**From:** [Craig Batchelor](#)  
**To:** [Danielle Petricevich](#)  
**Cc:** [CALEY, Helen](#); [PALMER, Brian](#)  
**Subject:** Allied Asphalt: Request for further information dated 28 February 2023 Geotechnical Matters  
**Date:** Thursday, 6 April 2023 2:00:00 pm  
**Attachments:** [Compiled ULS Results.pdf](#)

The Request for further information dated 28 February 2023 included the following on geotechnical matters:

**CPT file : CPT-03**

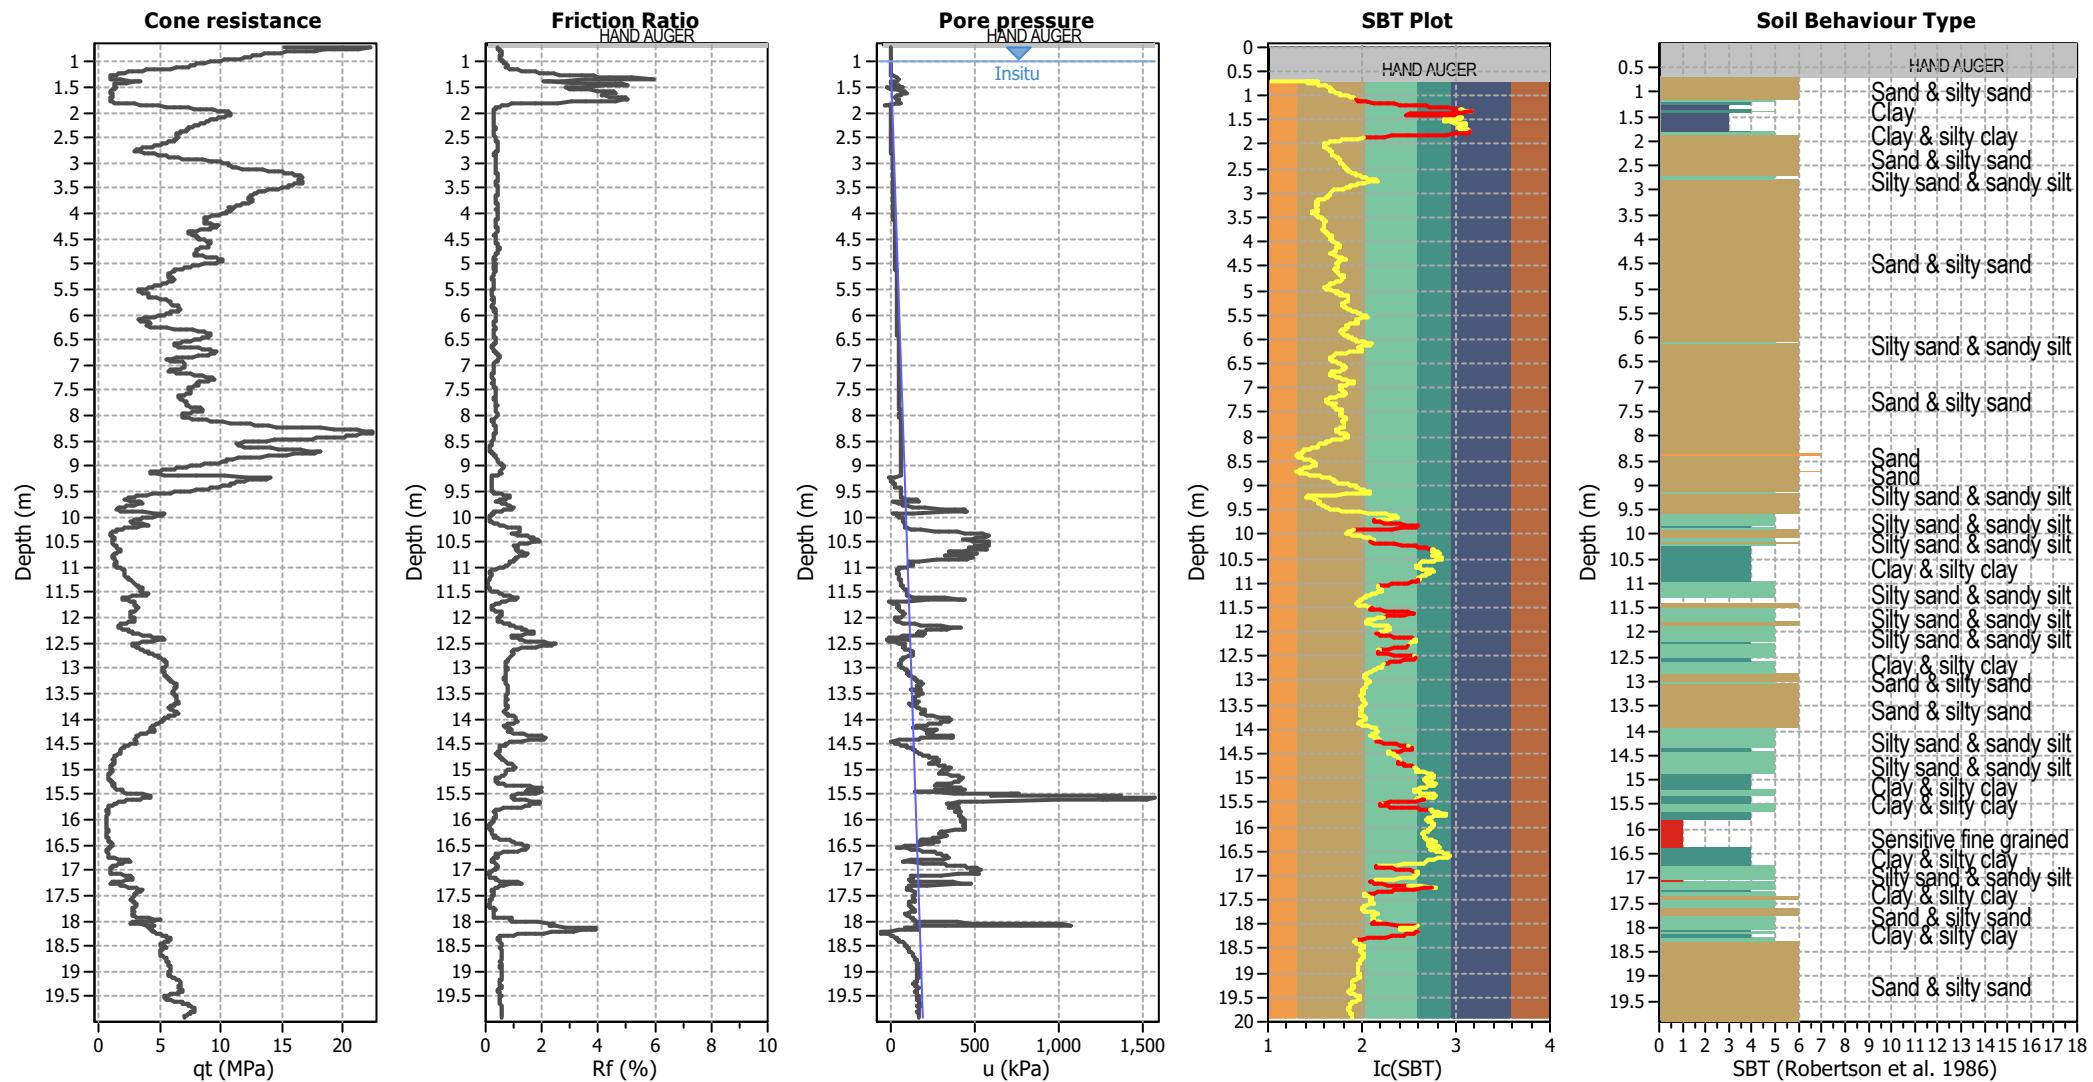
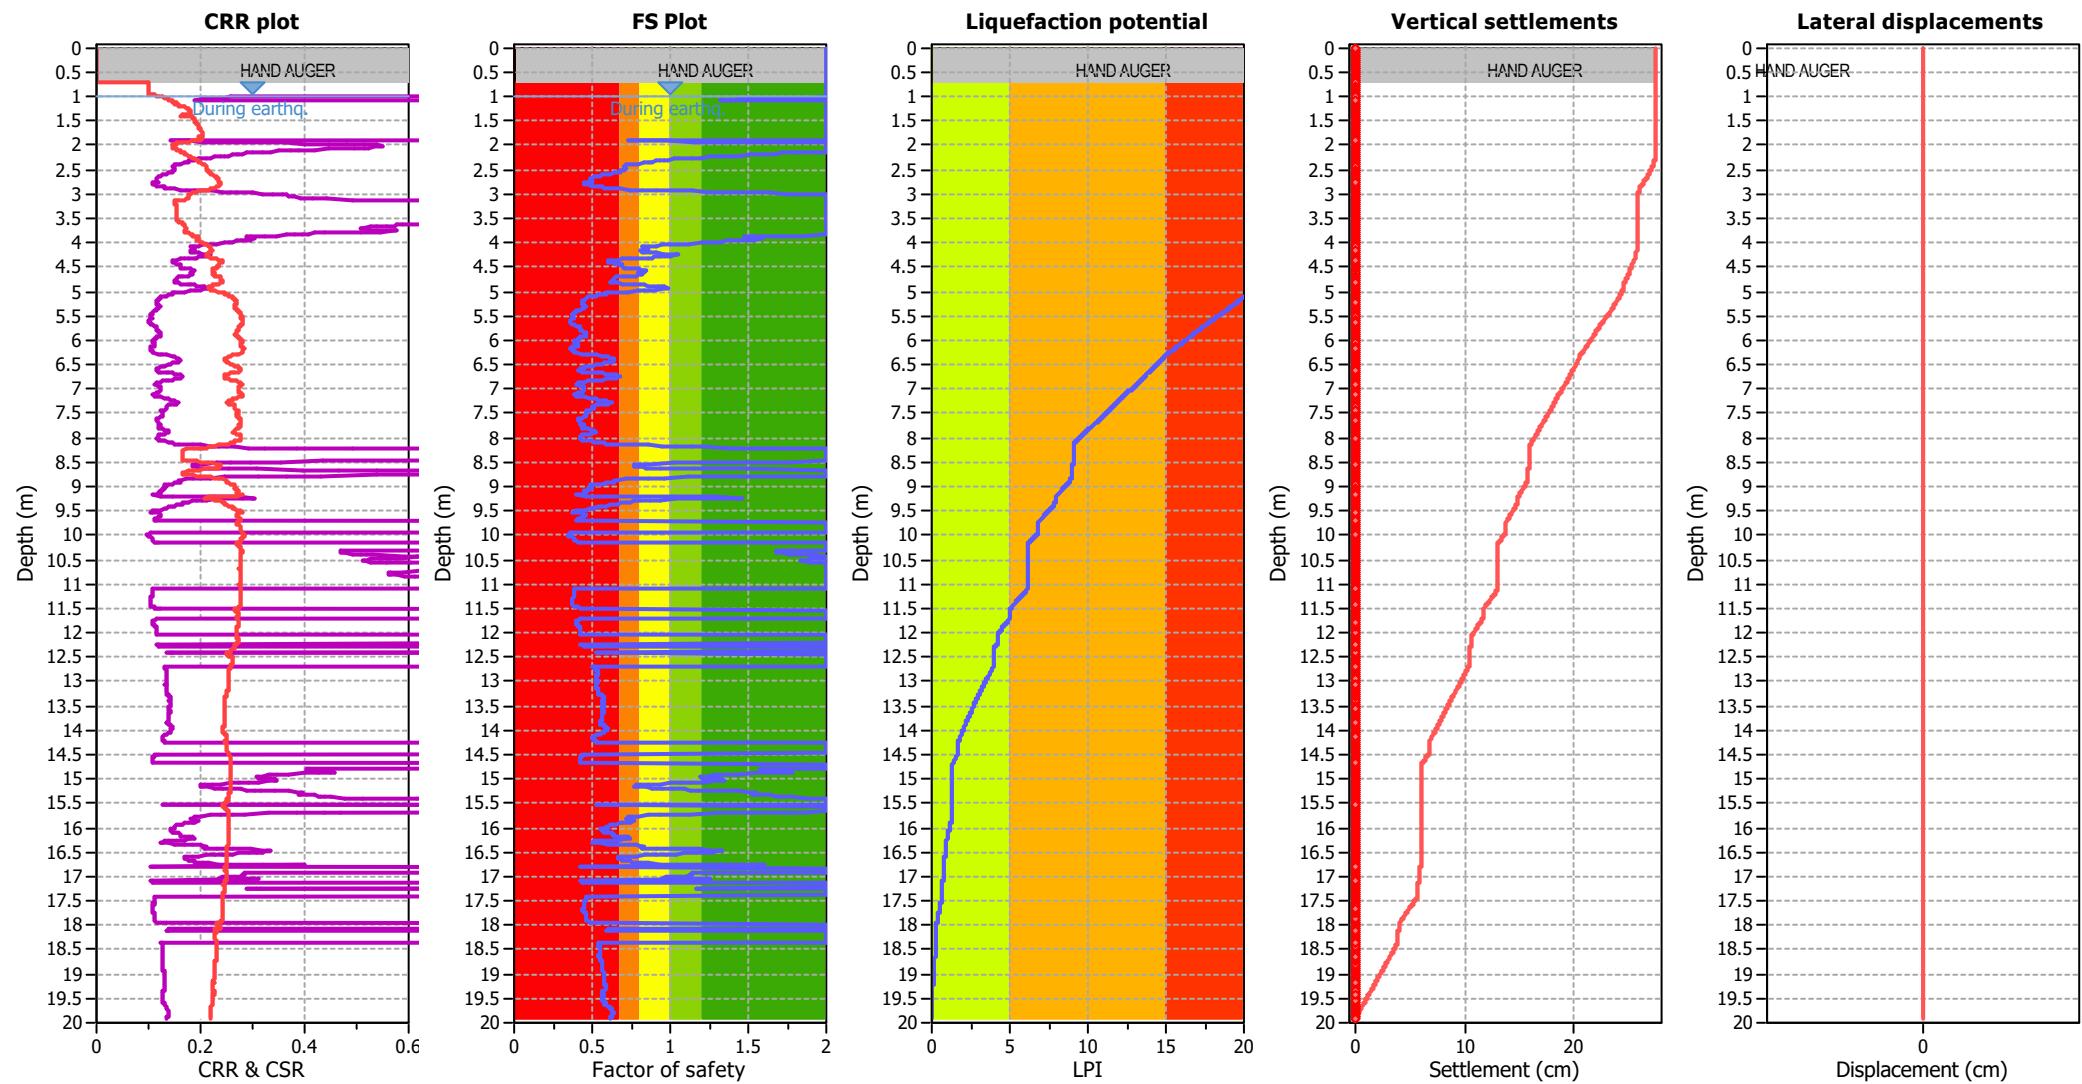
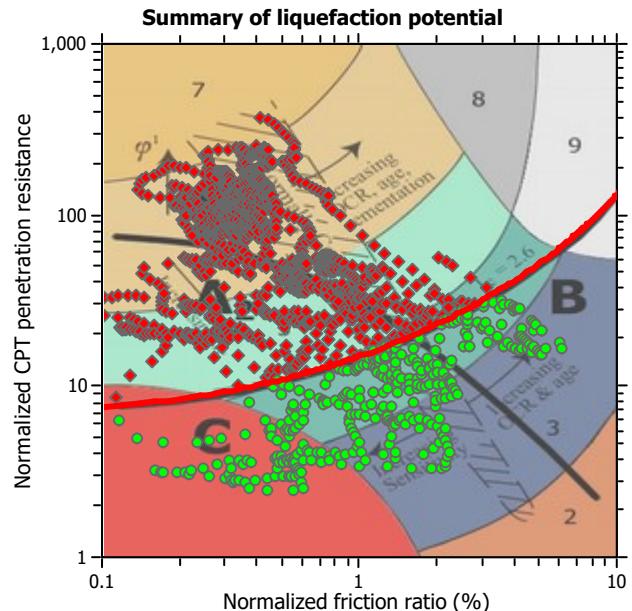
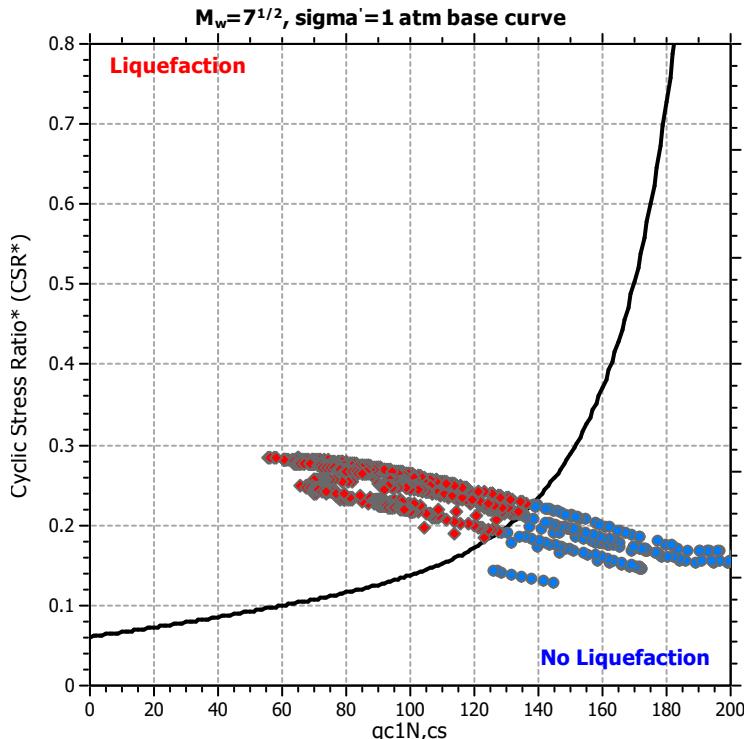
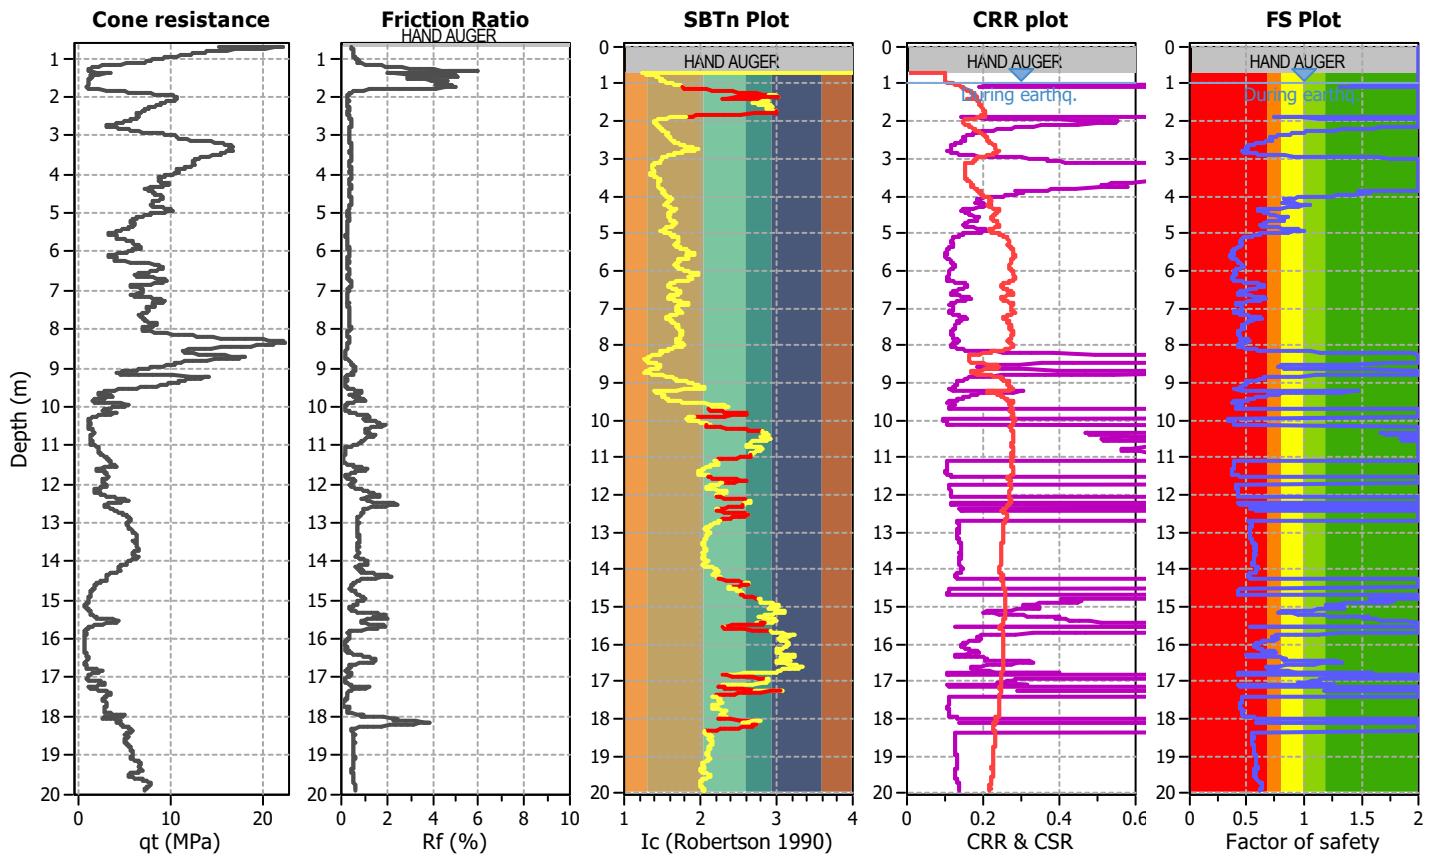
- a. Depth and magnitude of expected liquefaction under SLS and ULS conditions;*
- b. Approximate expected structural loads and required safe bearing capacity of soils;*
- c. Settlements as a result of the building loads;*
- d. Based on the above, the expected foundation type and ground remediation requirements for the asphalt plant;*
- e. Based on the above, the effect on neighbouring buildings/properties from the storage bins and construction works (ground remediation) for asphalt plant, if applicable, and assess mitigation options; and*
- f. Approximate revised earthworks volumes to include the expected areas and depths where shallow ground improvements are required."*

- a. Attached are example liquefaction result plots for the FH Mt Maunganui site. These are consistent with the stated hazard in the geotechnical assessment. These test results were not available at the time of the original assessment. The results use an estimated PGA that might change to suit the design requirements for the structures. The liquefaction predicted in the attached information may be over-estimated at depth. Good practice is to get lab testing samples to assess the plasticity of soils. This would be done as part of future design.
